## REMARKS

### Marked-Up Version of Amended Paragraphs and Claims (37 C.F.R. § 1.121)

Fig. 3

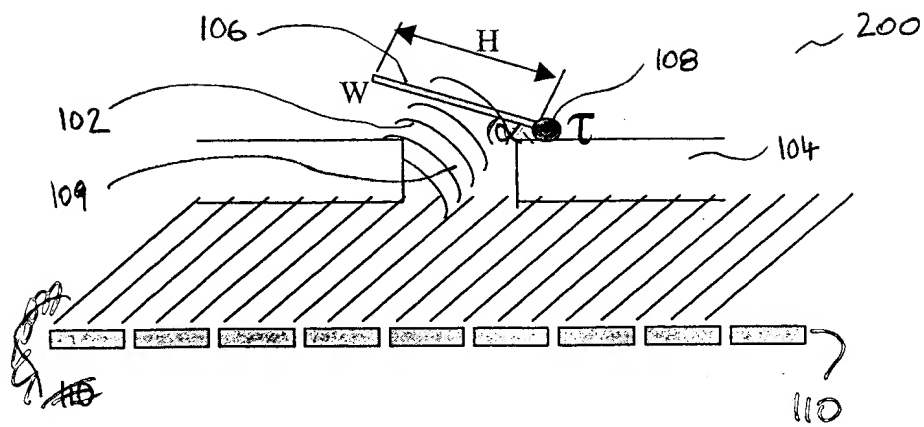
Fig. 3 is voluntarily amended to correct a clerical error. The line pointing to element 110 (an array of MEMS acoustic transducers) erroneously points to an angled launched acoustic wave rather than to the array of MEMS acoustic transducers. An appropriate correction of Fig. 3 is carried out and a copy of the Fig. 3 showing the change in red is submitted with this response for review by the Examiner. No new matter is introduced into the figures by way of this amendment.
